SUBJECT: Forwards response to 970417 RAI re 1995 inservice insp summary rept. Exam data sheets for each of exams limited by geometric, metallurgical or design/access restrictions, encl.

Docket 50-305  
Operating License DPR-43  
Kewaunee Nuclear Power Plant  
1995 Inservice Inspection Summary Report - Request for Additional Information

Response to NRC Request for Additional Information  
Regarding the 1995 Inservice Inspection Summary Report

COMPONENT IDENTIFICATION: APSI-1B-52  
APSI-1A-51  
APSI-1A-54 PROCEDURE: QCP-902 REVISION: ORIG

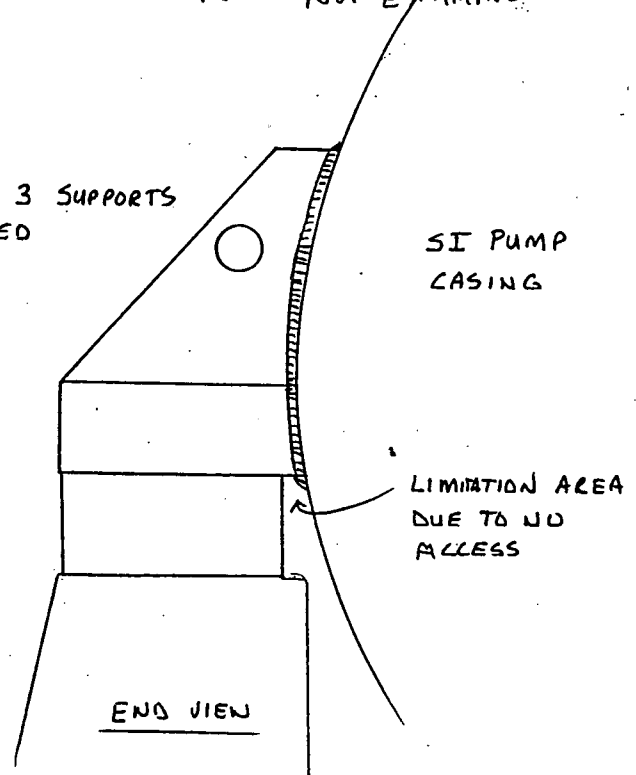
PERCENTAGE OF REDUCED EXAM COVERAGE 85.4% EXAMINED  
14.6% NOT EXAMINED

LIMITATION AREA ON BACK SIDE

LIMITATION AREA DUE TO NO ACCESS

COMPONENT IDENTIFICATION: PS-W34 PROCEDURE: QCP-901 REVISION: ORIG.

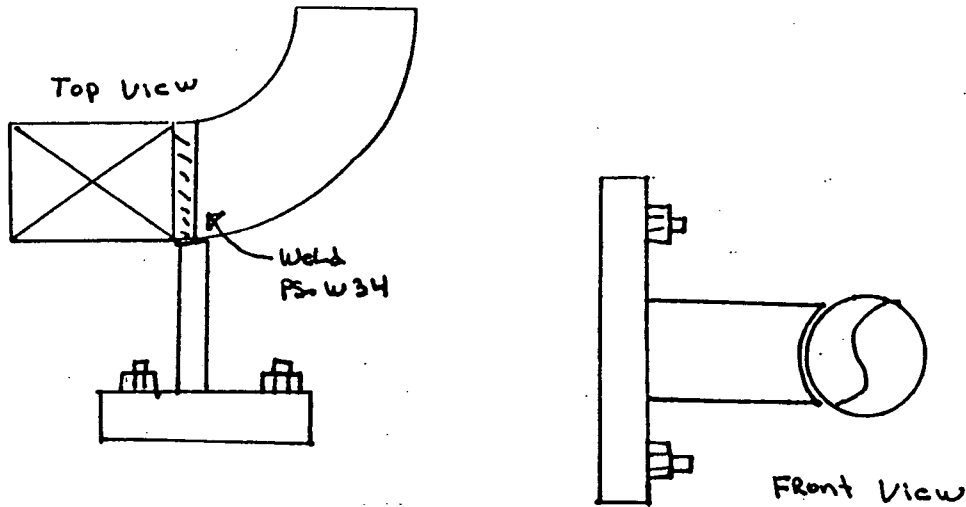
Whip Restraint Limits 3.5" OF CIRCUMFERENCE OF  
Weld FOR P.T. EXAM.

Percentage OF Reduced EXAMINATION COVERAGE = 63%

COMPONENT IDENTIFICATION: PS-w10 PROCEDURE: QCP-901 REVISION: ORIG

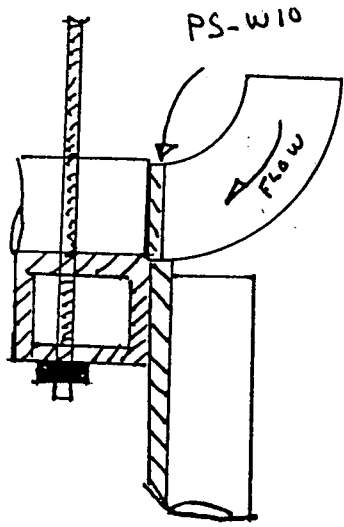
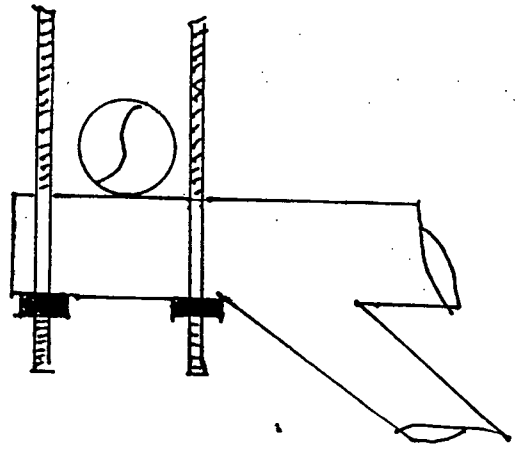
HANGER Support Limits P.T. EXAM AT  
Bottom of Weld For 4 inches.

COMPONENT IDENTIFICATION: SI-H17A PROCEDURE: QCP-901 REVISION: ORIG

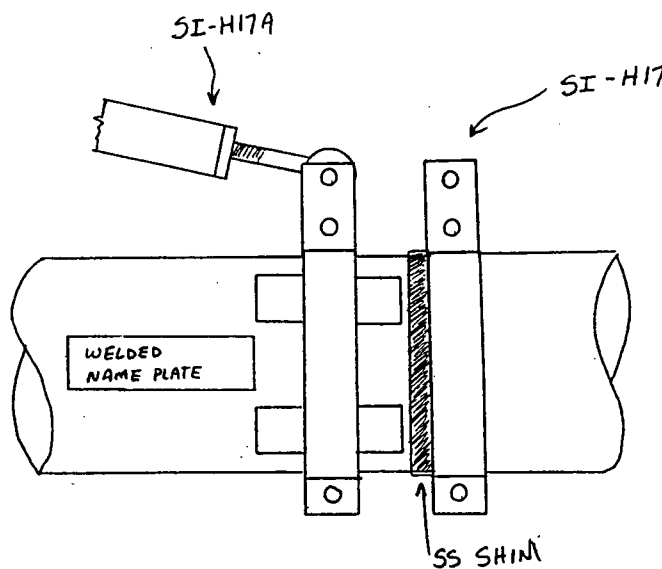
- NAME PLATE .20" FROM TOE OF WELD ON 2 LUGS

- STAINLESS STEEL SHIM @ TOE OF WELD ON 4 LUGS

PERCENTAGE OF REDUCED EXAMINATION COVERAGE = 90%

COMPONENT IDENTIFICATION: FW-W53 PROCEDURE: QCP-902 REVISION: 0216

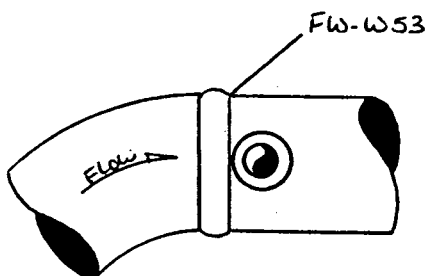
EXAM LIMITED TO WELD  $\frac{1}{2}$  UPSTREAM BASE METAL ONLY  
FROM 37.0" TO 42.0" CW. DUE TO AUL. FEEDWATER TIE-IN.

COMPONENT IDENTIFICATION: PR-W12 PROCEDURE: QCP-901 REVISION: ORIG.

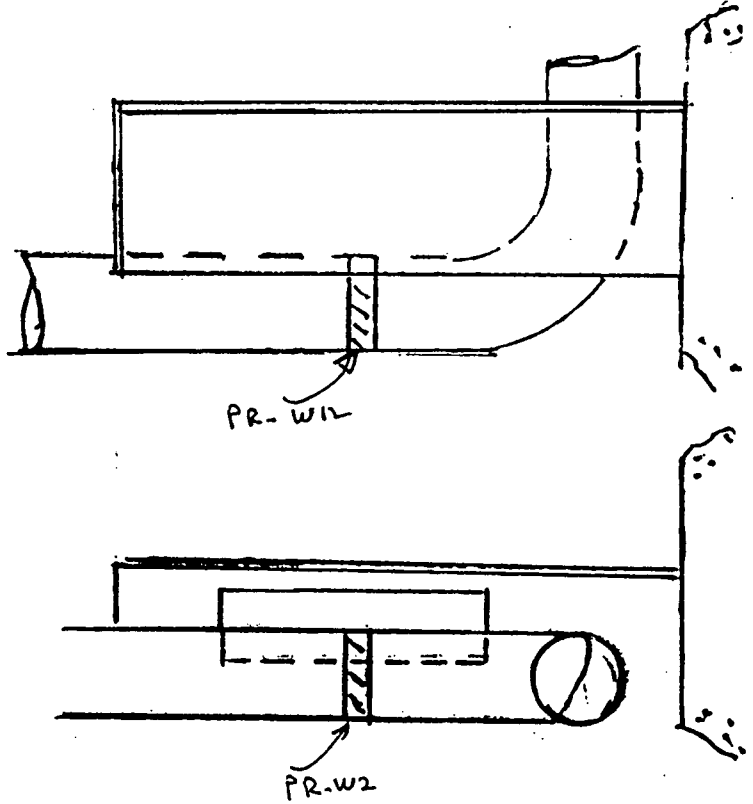
Whip Restraint Limited  
P.T. Exam. of weld  
PR-W12  
Percentage of Reduced  
Examination Coverage = 74%

COMPONENT IDENTIFICATION: P-W3 PROCEDURE: QCP 904 REVISION: ORIG

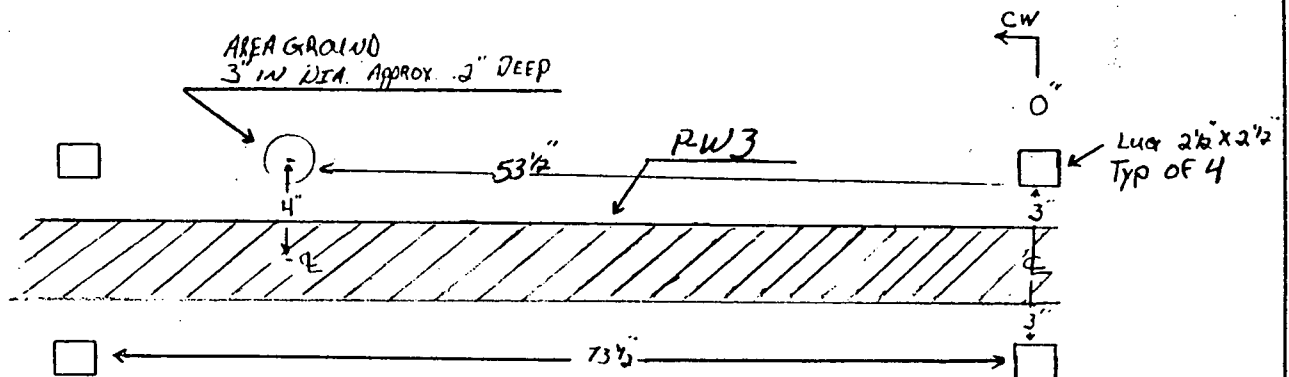
*REDUCED EXAMINATION COVERAGE LESS THAN 2%*

COMPONENT IDENTIFICATION: P-W5 PROCEDURE: QCP-904 REVISION: ORIG

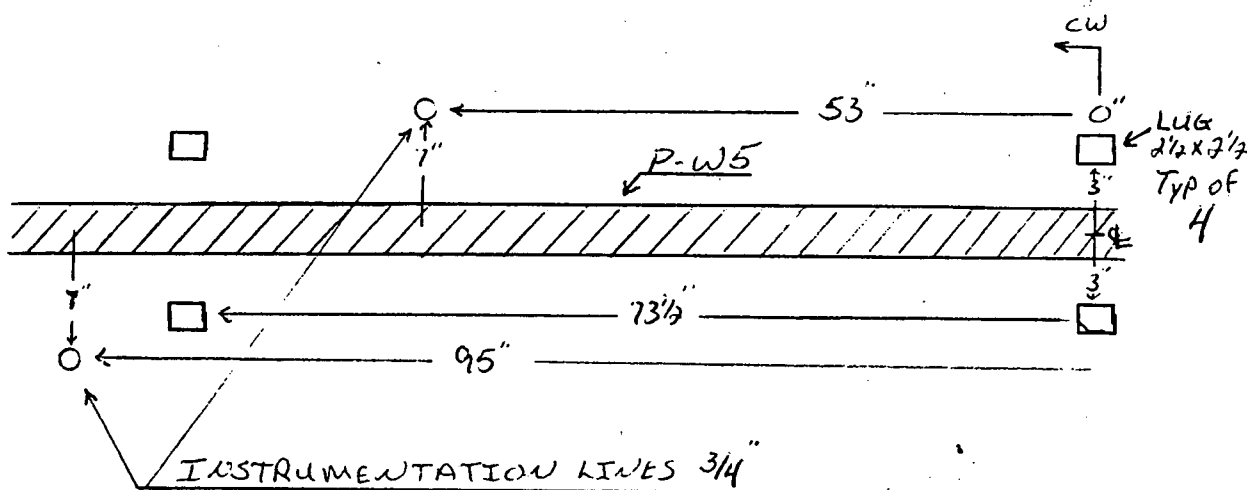
REDUCED EXAMINATION COVERAGE LESS THAN 2%

COMPONENT IDENTIFICATION: AHRS1-W1 PROCEDURE: QCP-911 REVISION: ORIG.

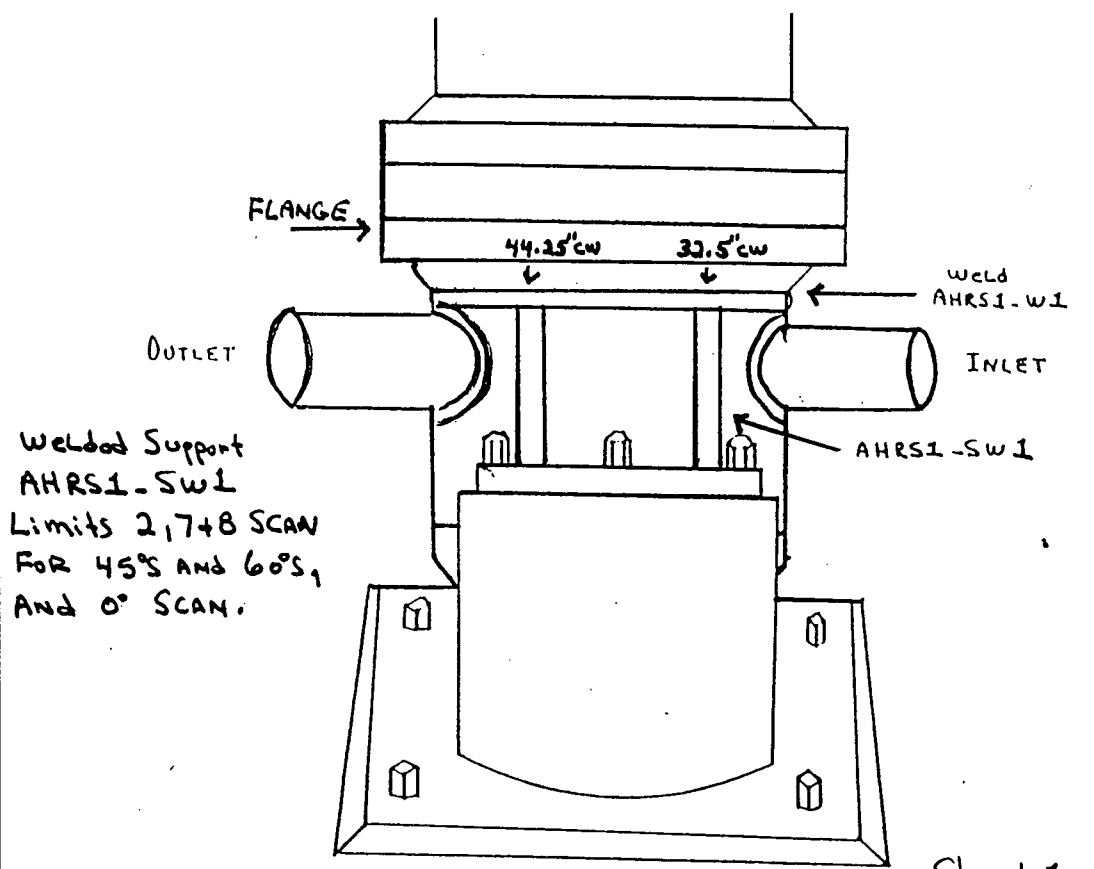
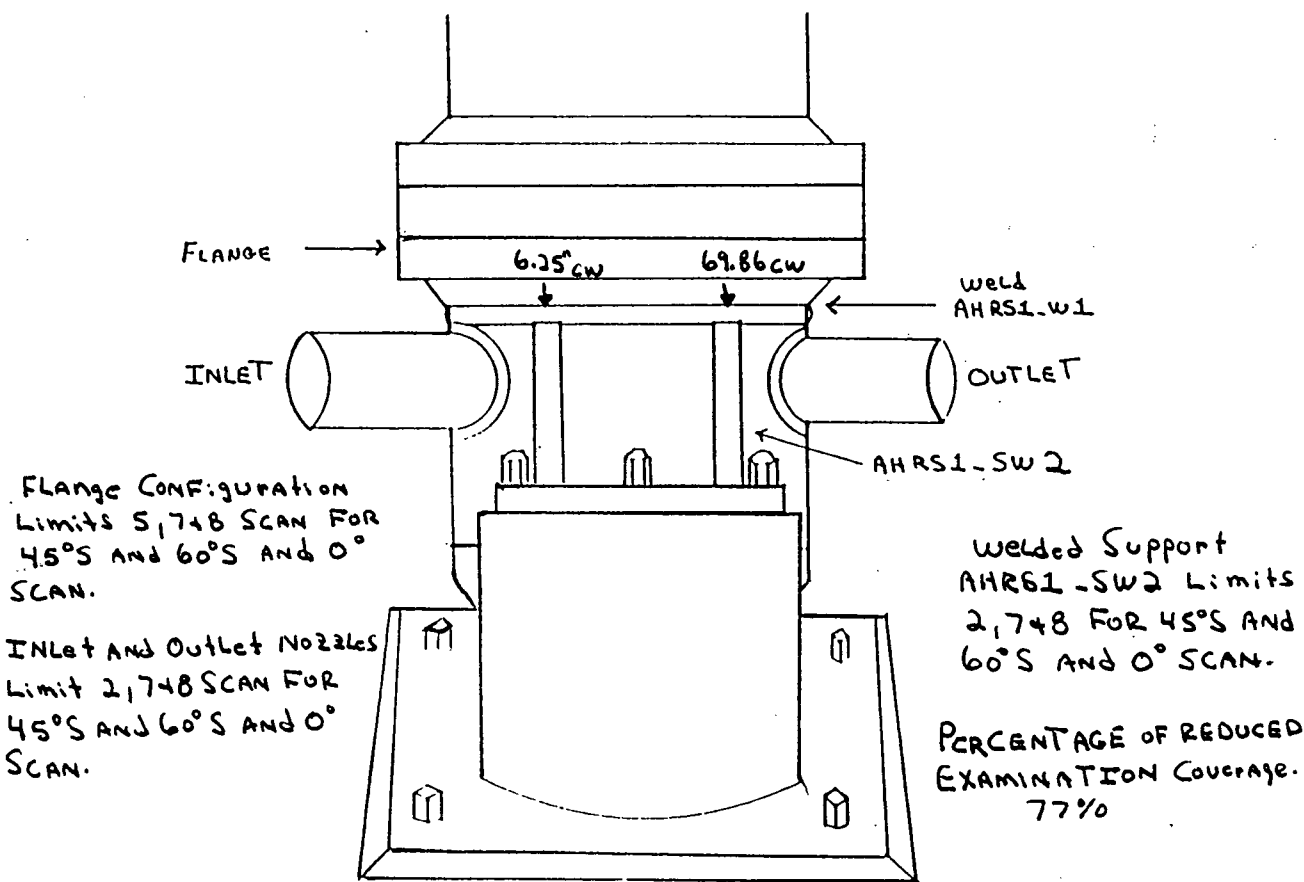
11-2	Circumferential Weld AHRSI-W1 on Residual Heat Exchanger AHRSI-1A	UT	77%. Inlet and Outlet Nozzles, Welded Support, and Flange Configuration	No

COMPONENT IDENTIFICATION: RV-W12 PROCEDURE: GCP 904 REVISION: ORIG.

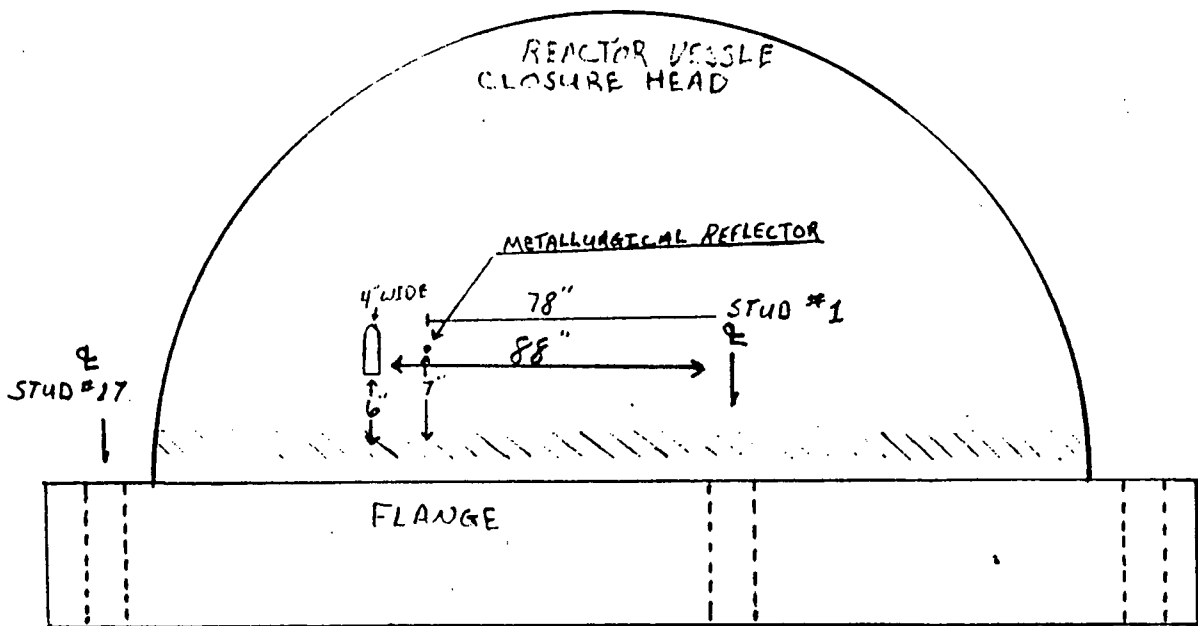
ULTRASONIC SCAN LIMITATIONS → LIFTING LUG AT 88" CW FROM Q OF #1 STUD.

SCAN LIMITED ON FLANGE SIDE TO 3" FROM WELD Q  
REFLECTOR IS OF METALLURGICAL ORIGIN AND DID NOT INTERFERE WITH THE  
45° OR 60° EXAMS

COMPONENT IDENTIFICATION: SI-W234 PROCEDURE: QLP-911 REVISION: ORIG

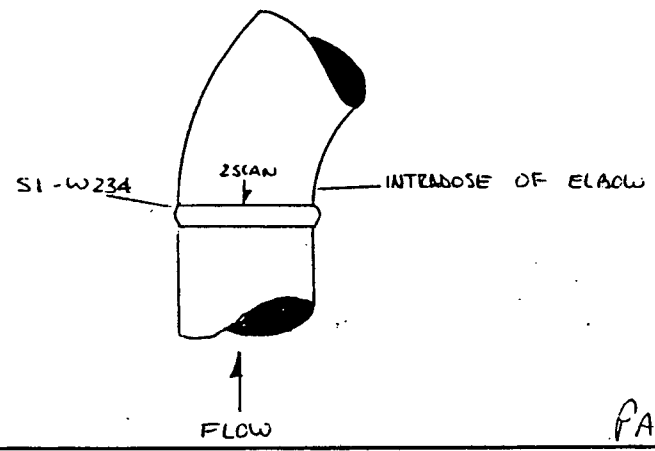
45° SHEAR AND 60° SHEAR, SCAN 2, LIMITED CONTACT FROM 6" TO 10" ON INTRADOSE OF ELBOW DUE TO CURVATURE OF ELBOW.

45° SHEAR - 20% REDUCED EXAM. COVERAGE  
60° SHEAR - 20% REDUCED EXAM. COVERAGE.

COMPONENT IDENTIFICATION: SI - W262 PROCEDURE: QCP-911 REVISION: ORIG

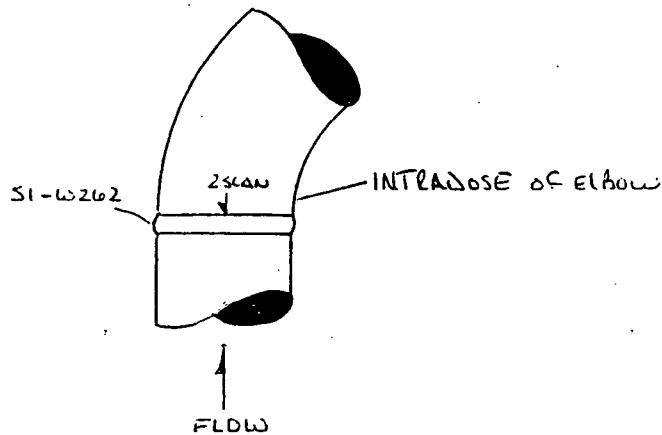
45° SHEAR AND 60° SHEAR, SCAN 2, LIMITED CONTACT FROM 6" TO 10" ON INTRADOSE OF ELBOW DUE TO CURVATURE OF ELBOW.

45° SHEAR - 20% REDUCED EXAM. COVERAGE.

60° SHEAR - 20% REDUCED EXAM. COVERAGE.

COMPONENT IDENTIFICATION: SI-W120 PROCEDURE: QCP-911 REVISION: 0216

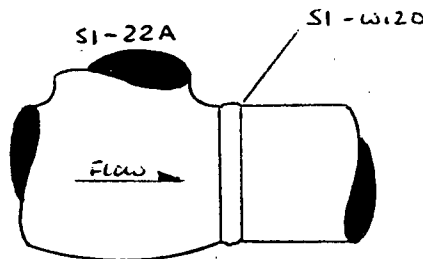
19-3	Circumferential Weld SI-W120 on 12" dia Safety Injection from Accumulator 1A	UT	50%. Valve to Pipe Configuration	No

COVERAGE NOT OBTAINED - 50%  
NO SCAN '5' DUE TO VALVE TO PIPE CONFIGURATION.  
SCAN '7' & '8' LIMITED TO WELD AND DOWNSTREAM BASE METAL ONLY DUE TO VALVE TO PIPE CONFIGURATION.  
OP SCAN ALSO LIMITED TO WELD AND DOWNSTREAM BASE METAL ONLY DUE TO VALVE TO PIPE CONFIGURATION.

COMPONENT IDENTIFICATION: SI-W123 PROCEDURE: QCP-911 REVISION: 0216

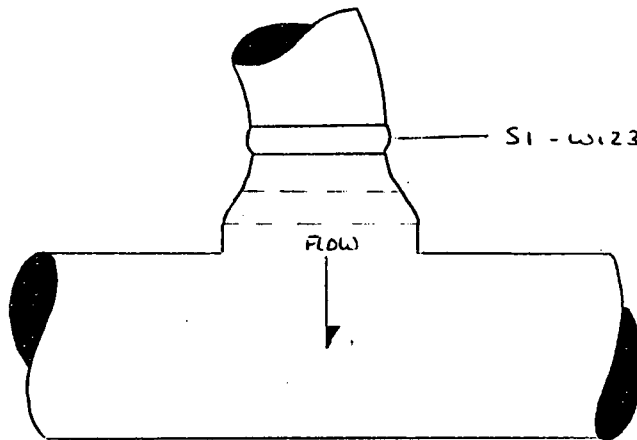
COVERAGE NOT OBTAINED - 50%  
NO SCAN '2' DUE TO ELBOW TO BRANCH CONNECTION CONFIGURATION.  
SCAN '7' & '8' LIMITED TO WELD AND UPSTREAM BASE METAL ONLY DUE TO ELBOW TO BRANCH CONNECTION CONFIGURATION.  
D° SCAN ALSO LIMITED TO WELD AND UPSTREAM BASE METAL DUE TO ELBOW TO BRANCH CONNECTION CONFIGURATION.

COMPONENT IDENTIFICATION: RHR-W188 PROCEDURE: QCP 911 REVISION: ORIG.

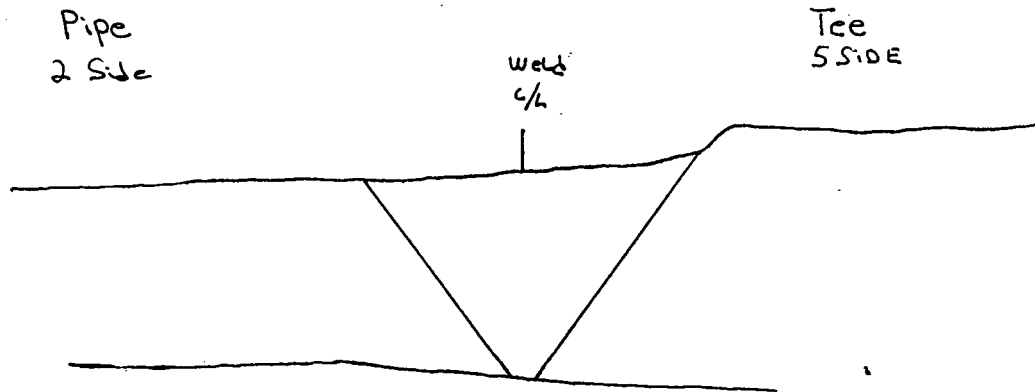
Tee Configuration Limited 0° SCAN AND S SCAN FOR  
45° S, 60° S AND 45° RL.

Percentage OF Reduced Examination Coverage = 49.8%

COMPONENT IDENTIFICATION: SI-W13 PROCEDURE: QCP-911 REVISION: ORIG

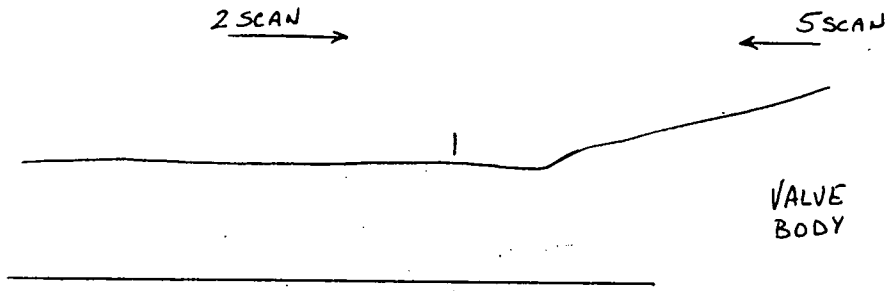
VALVE BODY LIMITED 5, 7 & 8 SCANS FOR 45°S, 45°RL  
60°S & 0° PERCENTAGE OF REDUCED EXAMINATION  
COVERAGE : 62.5%

COMPONENT IDENTIFICATION: SI-W14 PROCEDURE: QCP-911 REVISION: ORIG

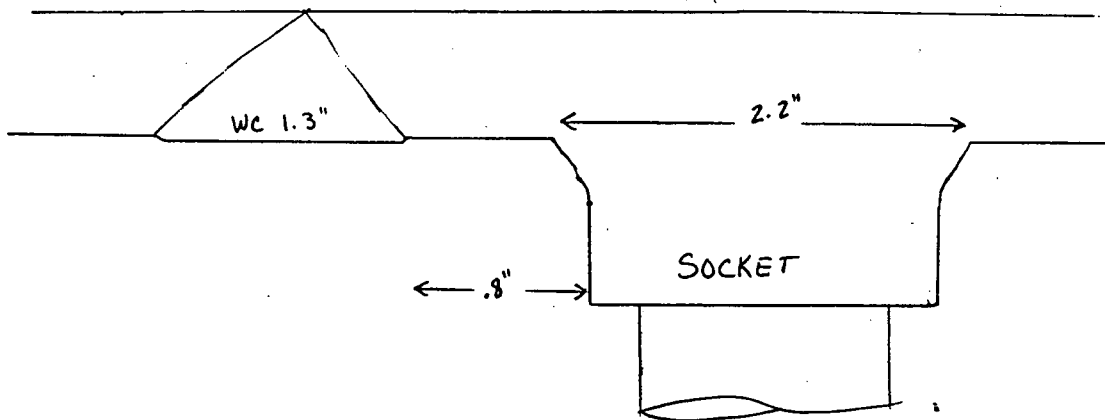
SOCKET @ 8.3" TO 10.5" .8" FROM TOE OF WELD

LIMITED SCANS 5 FOR THE 45°, 45°RL & 60°s

PERCENTAGE OF REDUCED EXAMINATION COVERAGE = 93.5%

COMPONENT IDENTIFICATION: FW-W53 PROCEDURE: QCP-913 REVISION: ORIG

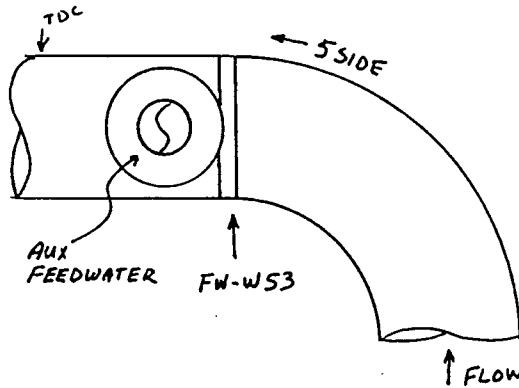
27-3	Circumferential Weld FW-W53 on 16" dia Feedwater Line	UT	11%. Auxiliary Feedwater Line	No

COMPONENT IDENTIFICATION: MS-W3 PROCEDURE: QCP-913 REVISION: ORIG

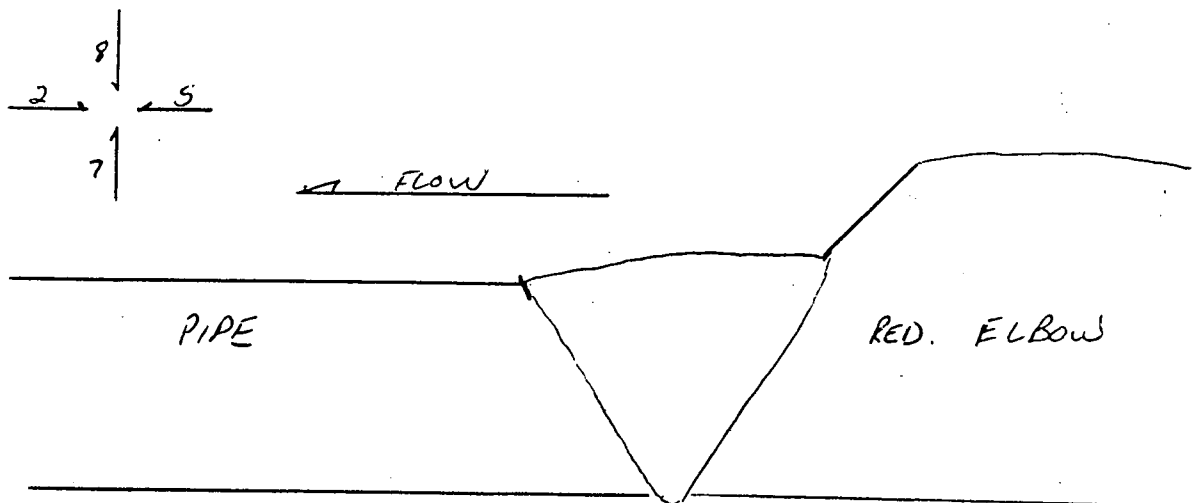
NO SCANS 5, 7, 8 ON RED. ELBOW DUE TO OD TAPER AND THICKNESS CHANGE. NO 0° SCAN DUE TO TAPER.
